PARTS DEPARTMENT BULLETIN

DATE:	6-Feb-14	BULLETIN NUMBER:	2014-2 page 1
SUBJECT:	5.0 / 4.2 and 6.5 / 5.4 SBCG throttle body part	numbers, addition of r	ev-limiter.
DETAIL:	The purpose of this bulletin is to clarify throttle body and electronic control unit (ECU)		
	part numbers used on Low Profile, Low Co SBCG products. Please consider the		
	following detail before placing orders for thes	se parts.	
	Units manufactured up to and including E803	date code are 50 or 60	HZ specific, the
	factory speed setting can not be changed. The	MENTAL CONTROL DE L'ANTINO DE	
	body, number 48966, and ECU number 49789	INTERNAL PROPERTY OF THE PROPE	Se sole tillottie
	Units manufactured after E803 date code are capable of being field converted for 50 or 60 HZ. Reference Operator Manual 49740, edition 3, page 28 for details regarding field		
	Company and the second and administration of the second and admini	DICTAL PRANCESCOCKANAMENT REPORTE DISTANCE CONTRIBUTION OF THE ARCHITICAL PROPERTY OF THE ARCHITICAL P	THE REPORT OF THE PROPERTY OF

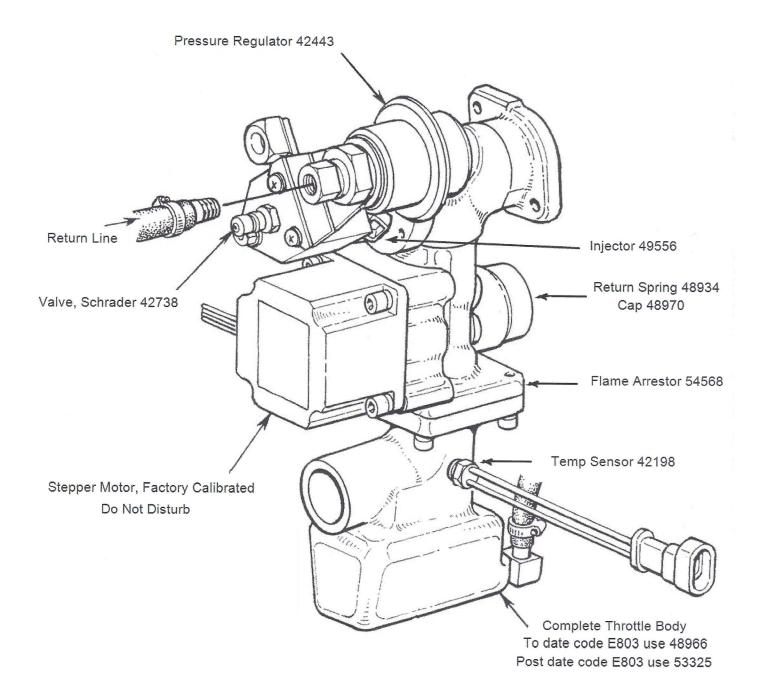
T-Body PN 48966 has a large bore throttle plate, it is used with ECU PN 49789.

T-Body PN 53325 has a small bore throttle plate, it is used with ECU PN 53347.

Large Bore T-Body 5.0 and 6.5 SBCG products are not adjustable to 50 or 60 HZ.
